BOARD OF VARIANCE

3. Board of Variance Application BOV00030 Annex B
(1223 Lockyer Road, Electoral Area D – Roberts Creek) pp 7 - 88

Applicant:	Richard Johnson / Kenton Braine
Civic Address:	1223 Lockyer Road
Legal Description:	LOT A BLOCK 2 DISTRICT LOT 1318 PLAN 17244, PID: 007-297-939
Electoral Area:	D: Roberts Creek
Parcel Area:	~7203 m ² (1.78 ac)
OCP Land Use:	Country Residential
Land Use Zone:	Country Residential One (CR1)
Application Intent:	To allow for the construction of a residential driveway with vehicle-access bridge over Flume Creek

This is Version 4 of the RAPR Assessment No. 7720. In this version, the proposed alignment and design of the driveway is revised to be perpendicular to the banks of the watercourse, and the arborist report is revised and updated.

APPLICATION 2021-02052	
1223 LOCKYER ROAD	
TREE MAP DRIVEWAY PLAN	
SCALE: 1:250	DATE: October 16, 2024
DRAWING NUMBER: K003	SHEET...1...OF...1... REVISION:.....3....

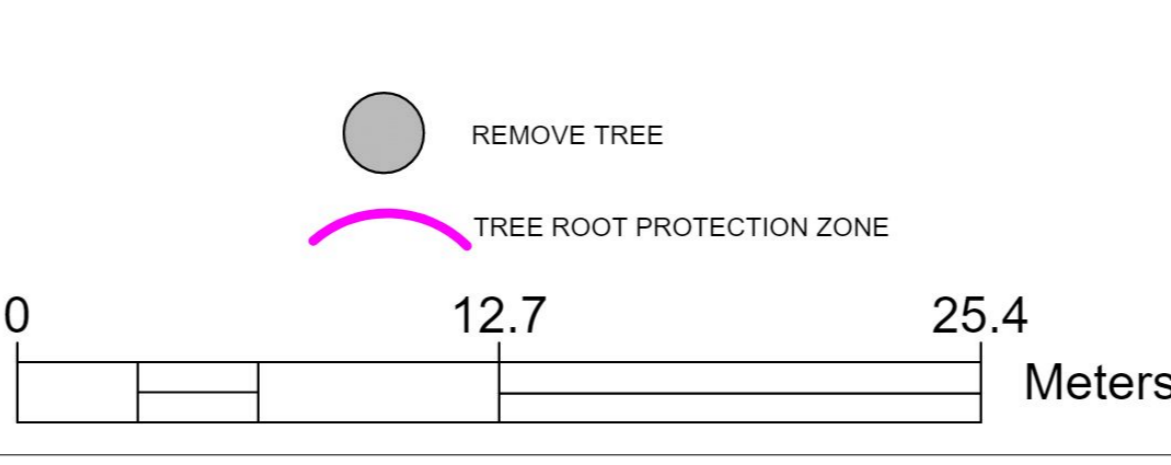
- **It is understood previous access to buildings on west side of property are no longer available.**
- As previously stated, the installation of a crossing precludes RAPR boundaries from that area as RAPR boundaries are measured perpendicular to the Stream Boundary. As such, access routes (e.g., driveways) are to be contained within the crossing 'right-of-way' until outside of the SPEA and SPEA protection areas. How does the proposed route been determined to minimize encroachment into the SPEA? Has the route been considered as it relates to the RAPR spirit and intent? It is noted the geotechnical report discusses potential geotechnical hazards in relation to the proposed design but does not address other options in relation to the SPEA. What other options are available?
 - The Geotechnical Engineer states the following:

- Tree inventory does not include an assessment of the critical root zones of any tree. Tree inventory mapping should clearly show which trees are proposed for removal and which are not. Given that development is to occur within the SPEA, tree protection fencing is to be shown around all protected trees in the vicinity of all proposed works.

- Section 10 of the RAPR.
 - Please provide a rationale for the location of the driveway. The figure on Page 34 shows a driveway outside of the SPEA from the southwest side of the property, can this access not be used? The alignment of the access should be perpendicular through the SPEA to minimize the area of encroachment. If this cannot be achieved, please provide information on why. How does the proposed location meet the BC Environmental Mitigation Policy hierarchy to first avoid and then minimize impacts? Since the area if the SPEA is calculated the increase in SPEA width cannot be legally enforced. Have any areas for restoration or habitat enhancement been identified as potential areas of compensation?

2. The alignment of the access should be perpendicular through the SPEA to minimize the area of encroachment. If this cannot be achieved, please provide information on why.

3. Location of driveway crossing does not meet crossing standards and must cross at a discrete perpendicular location, reducing impacts to the SPEA significantly. Amendment of site plan showing discrete crossing is required, and crossing will require a Water Sustainability Act authorization. Crossing must follow Water Sustainability Regulation standards for fish crossing.

1. In response to the comment on the proposed route, the Developer has changed the route alignment to shorten the length of the driveway inside the SPEA. Please refer to their comments on the next page. The new proposed site plan is provided in Section 3.

2. In response to the comment on the tree inventory, the project arborist has updated and revised the tree inventory and their assessment of hazard trees due to the storm seasons that have transpired since their original site assessment. Their updated tree inventory report is appended to this RAPR assessment. Their recommendations for tree and tree root zone protection are described in the report and on the site plan in Section 3.

4. With regard to the development envelope, the site plan has been revised to address this comment.
